Project: DBVI Azalea Avenue Campus – Replace Fire Alarm System in Five (5) Buildings
Project Code: 702-13942-29

RE: **Addendum No. 2**

Addendum No. 2 dated August 30, 2010, to Bidding Documents for Department for the Blind and Vision Impaired – Richmond, VA: Replace Fire Alarm System in Five (5) Buildings at the Azalea Avenue Campus, Plans and Specifications dated August 4, 2010, K&A File No. 10012.

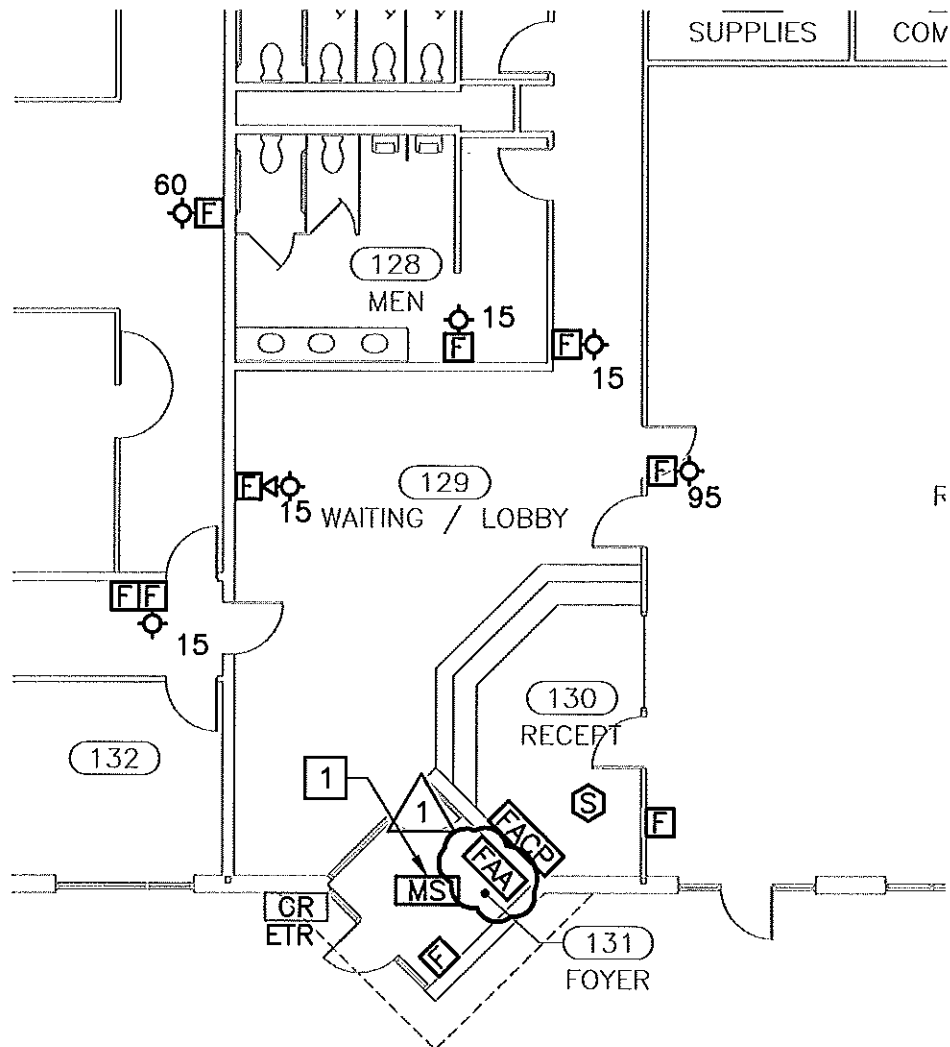
E5, E7, and E15: See attached sketches SKE-1, SKE-2, and SKE-3 (See attached).

3. Question Re E19: Riser shows Annunciator, Floor plan does not. Is there a requirement for an annunciator in the Library?

Riser shows Annunciator, Floor plan does not. Is there a requirement for an annunciator
in the Library?

Response: Yes. See attached Sketch SKE-1.

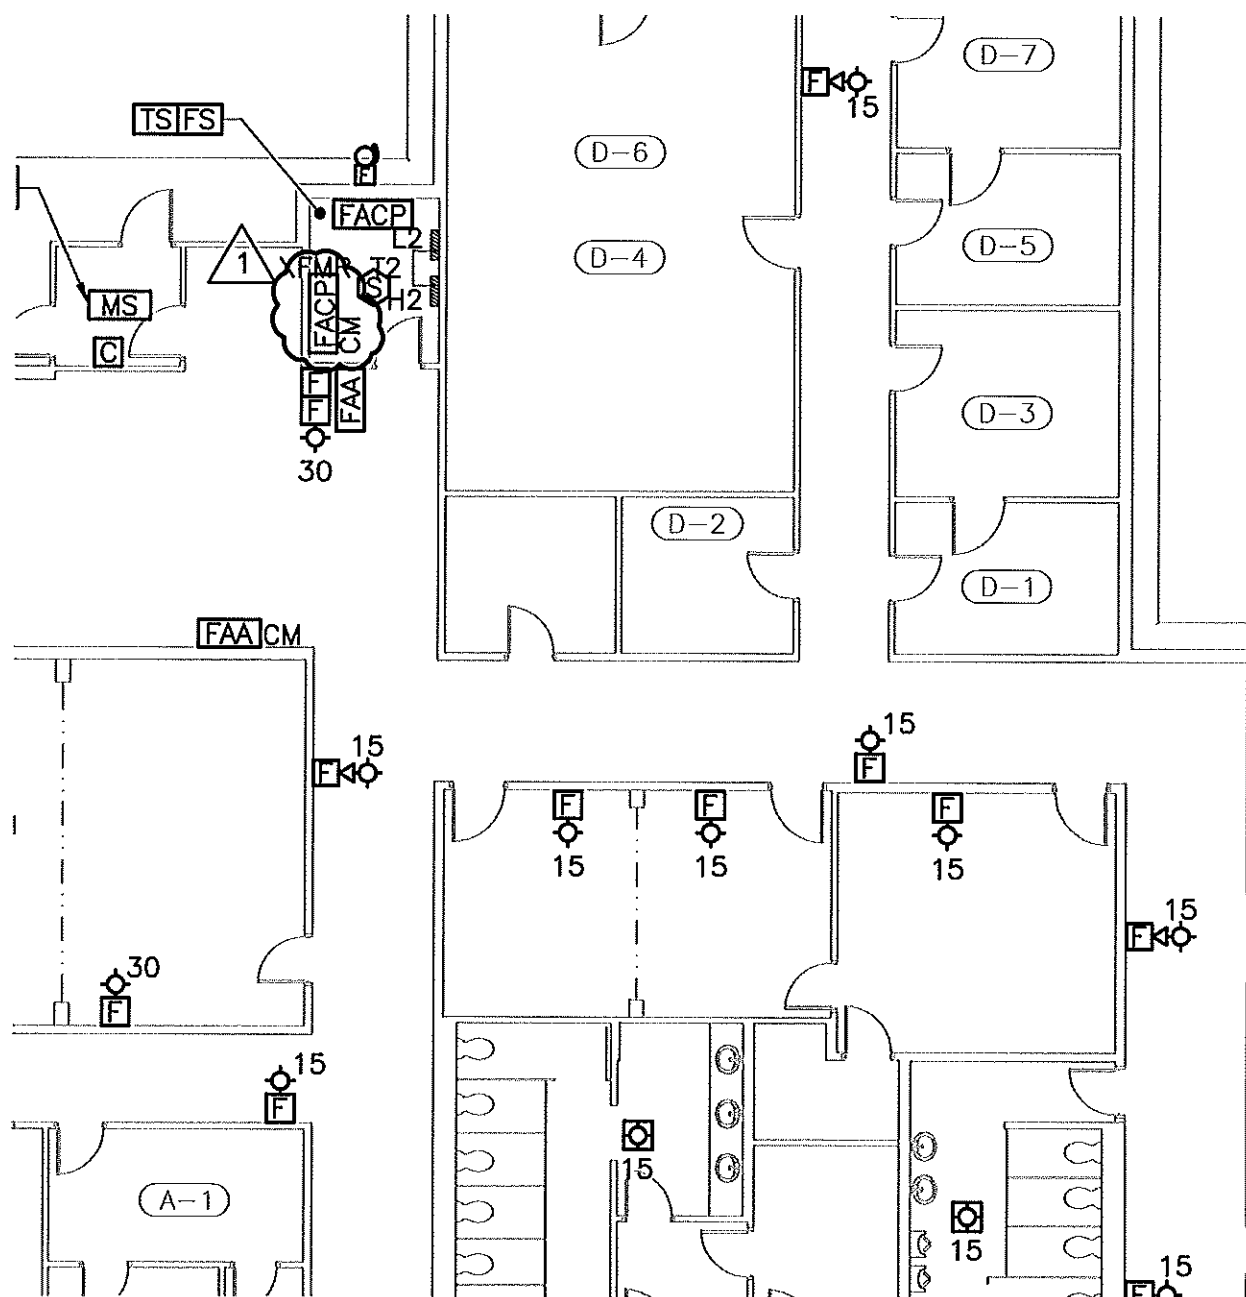
4. Question Re E5 & E15: These drawings show the two Campus Monitoring Fire Alarm Control Panel and the Campus Monitoring Fire Alarm Annunciator side-by-side. If the Campus Monitoring Fire Alarm Control Panel has a display then the Campus Monitoring Fire Alarm Annunciator would be a duplicate display. Can we delete the annunciator if the FACP has the capability of a display?

Response: No. A separate annunciator is required as indicated. See Sketches for revised control panel locations.
